The original solicitation for the project noted above is amended as noted.

Bid Schedule: ADDENDUM 3 - 2018 7th Street Reconstruction - North Ave. to Orchard Ave.

7TH STREET RECONSTRUCTION MARCH, 2018

7TH STREET RECONSTRUCTION
STA 0+00 - STA 15+00

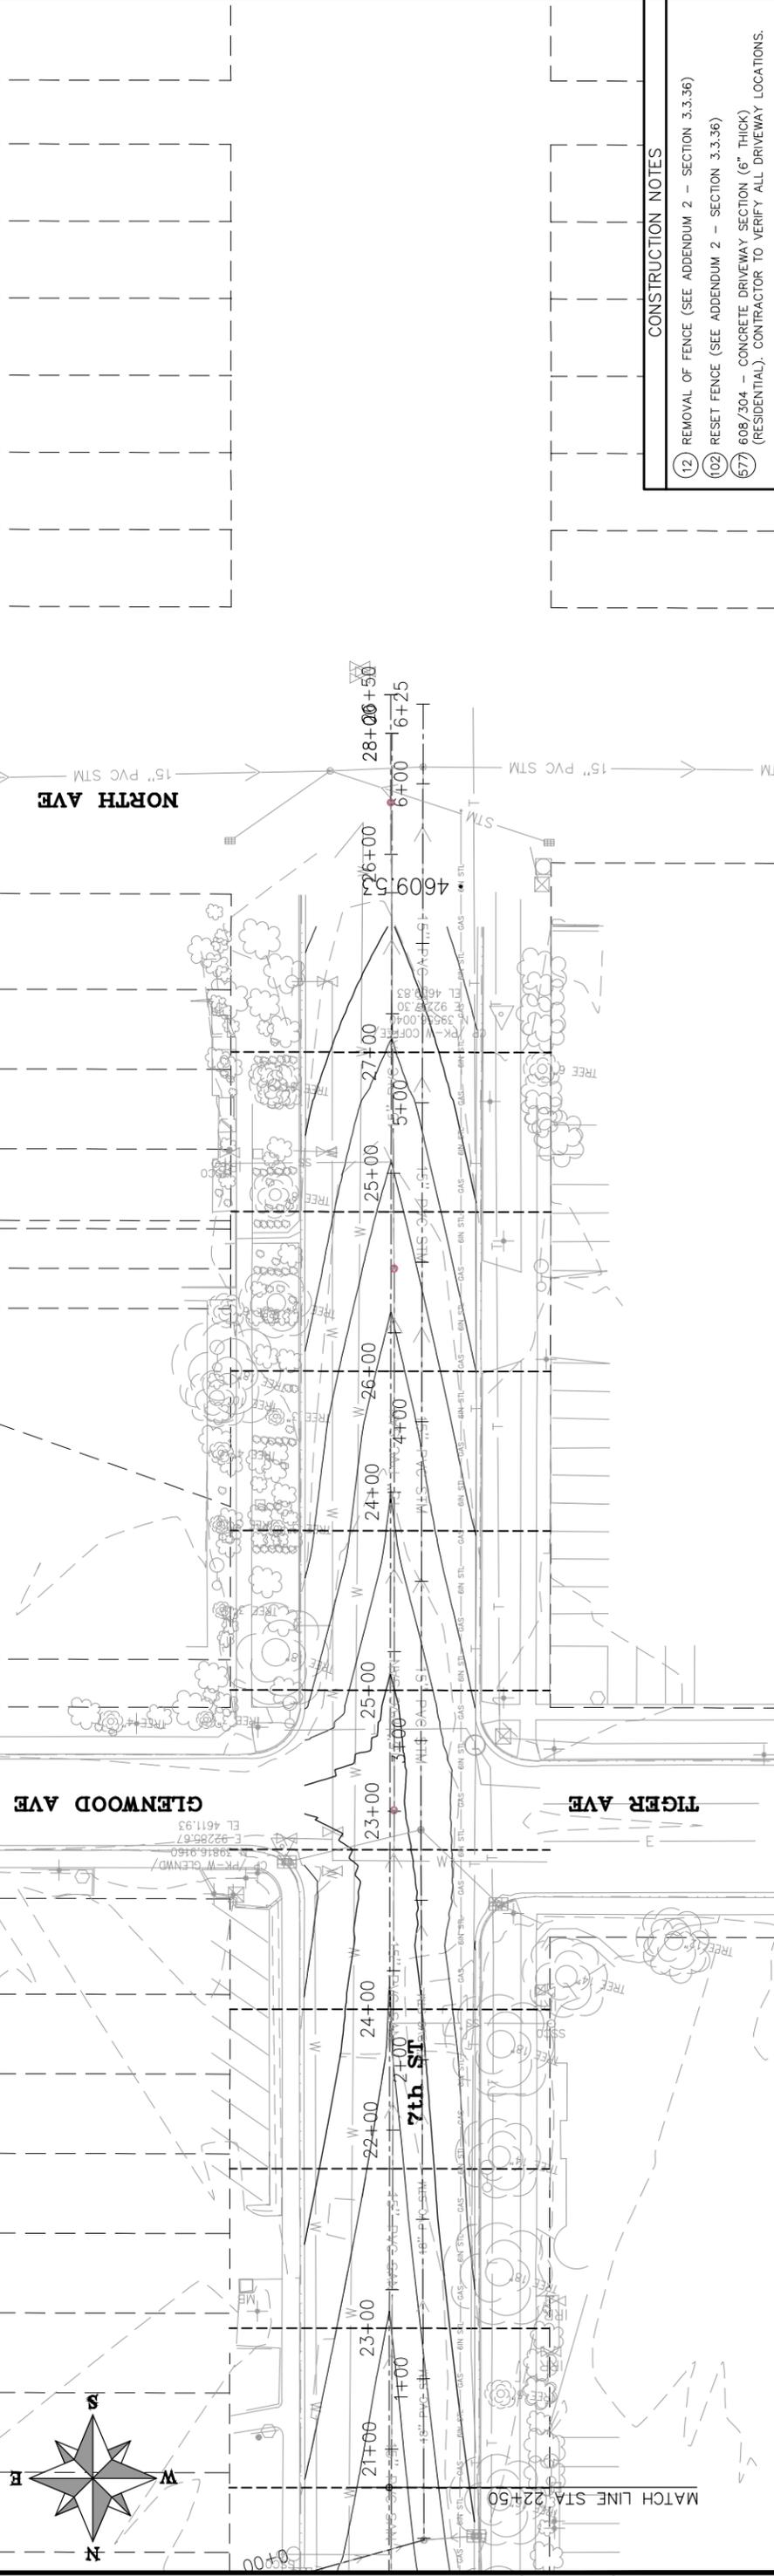
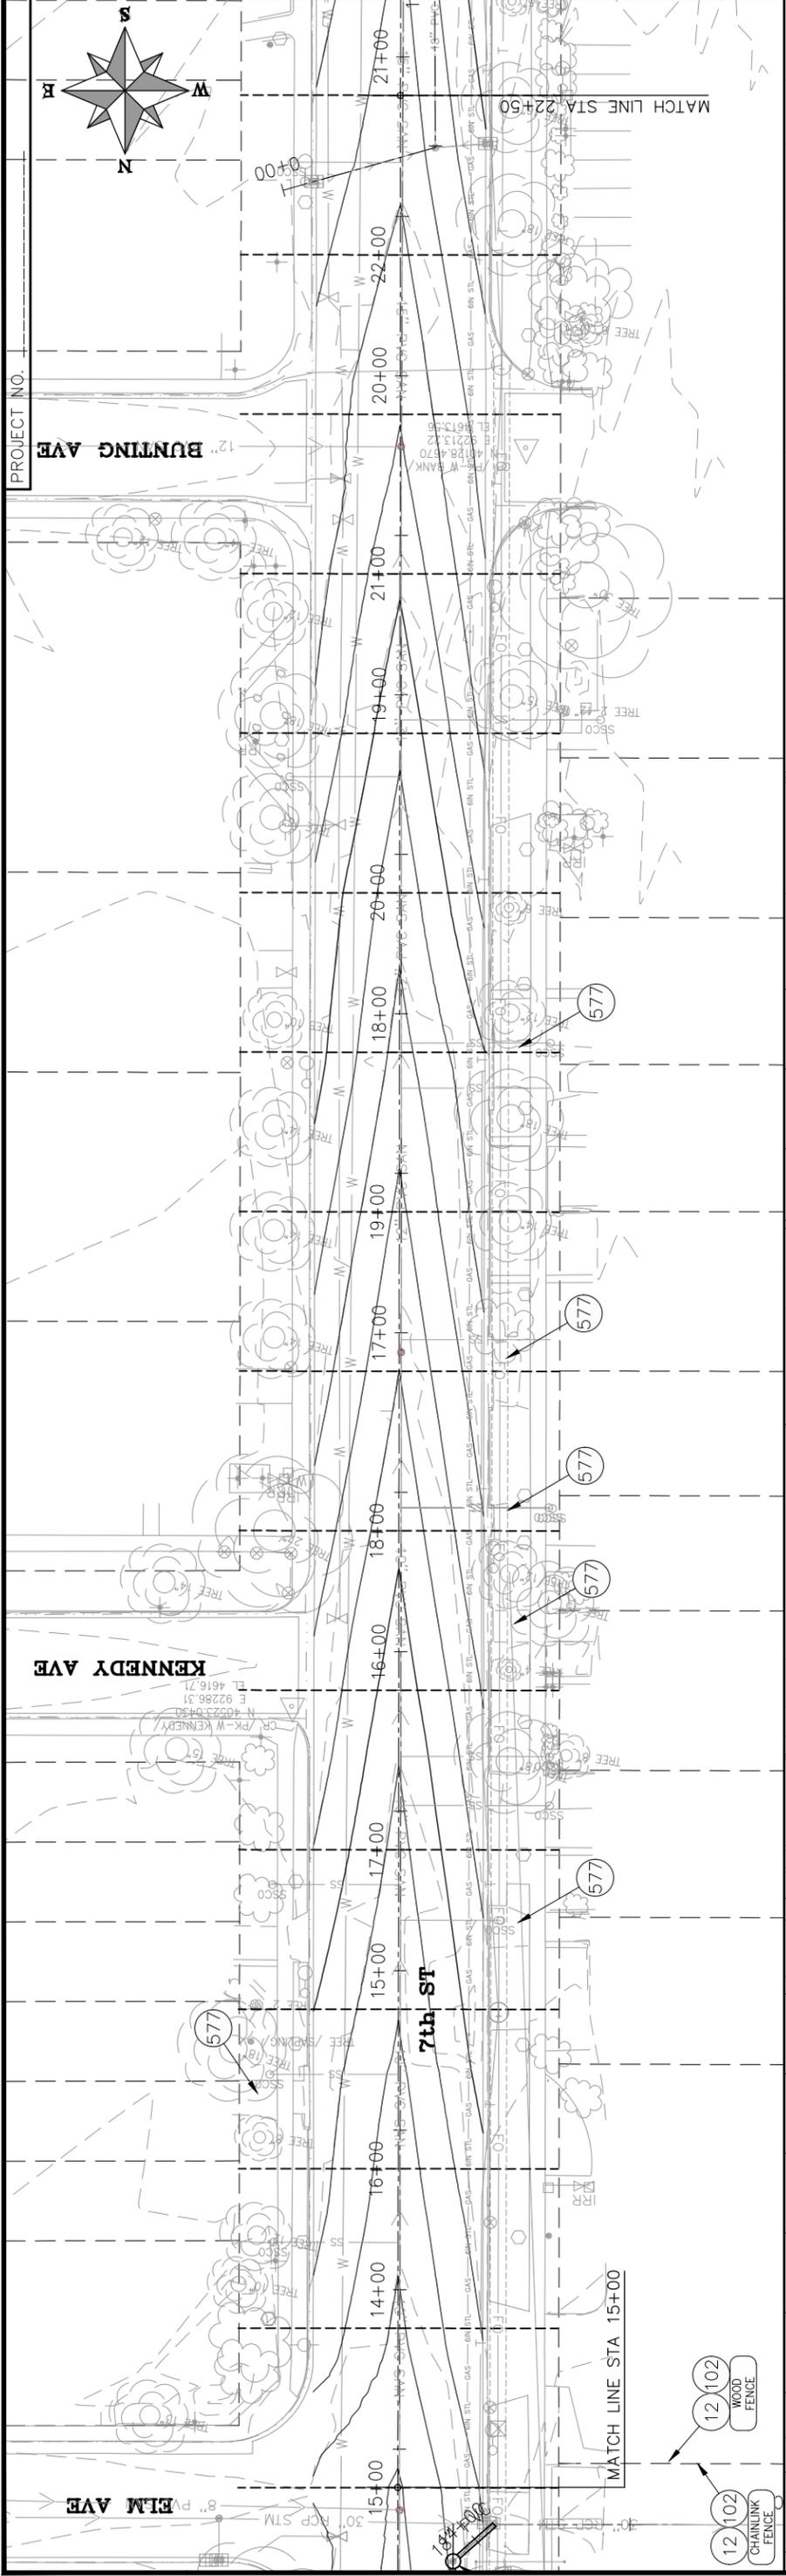
- CONSTRUCTION NOTES**
- 12 REMOVAL OF FENCE (SEE ADDENDUM 2 - SECTION 3.3.36)
 - 102 RESET FENCE (SEE ADDENDUM 2 - SECTION 3.3.36)
 - 577 608/304 - CONCRETE DRIVEWAY SECTION (6" THICK (RESIDENTIAL)). CONTRACTOR TO VERIFY ALL DRIVEWAY LOCATIONS.
